AMENDMENTS OF THE DRAWINGS

Application No.: 09/911,757 Confirmation No.: 5003

For: SUPPRESSION OF RINGING ARTIFACTS DURING IMAGE RESIZING

F1G. 4

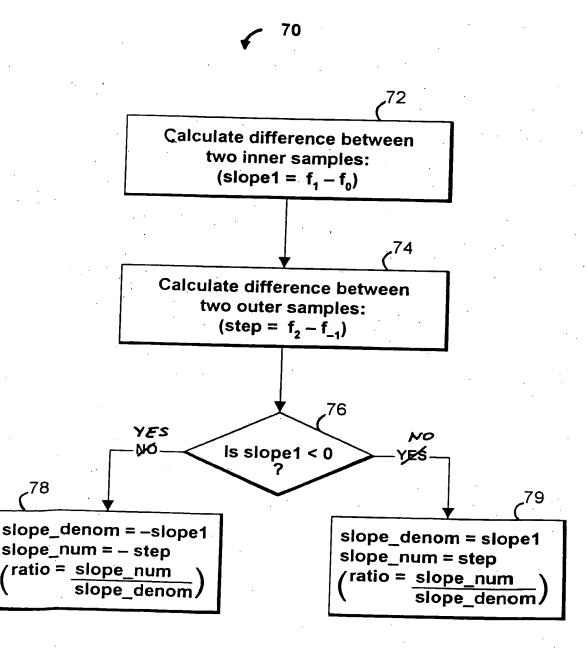
The attached Replacement Sheet 4 of the drawings includes changes to FIG. 4. This sheet, which includes only FIG. 4, replaces the original Sheet 4 including only FIG. 4. In replacement FIG. 4, (1) the the arrow from decision block 76 to block 78 has been labeled --YES--, and (2) the arrow from decision block 76 to block 79 has been labeled --NO--.

Applicant has amended FIG. 4 to correct the "Yes" and "No" labels corresponding to the arrows from decision block 76. Support for this amendment may be found in the specification at page 13, lines 14-25.
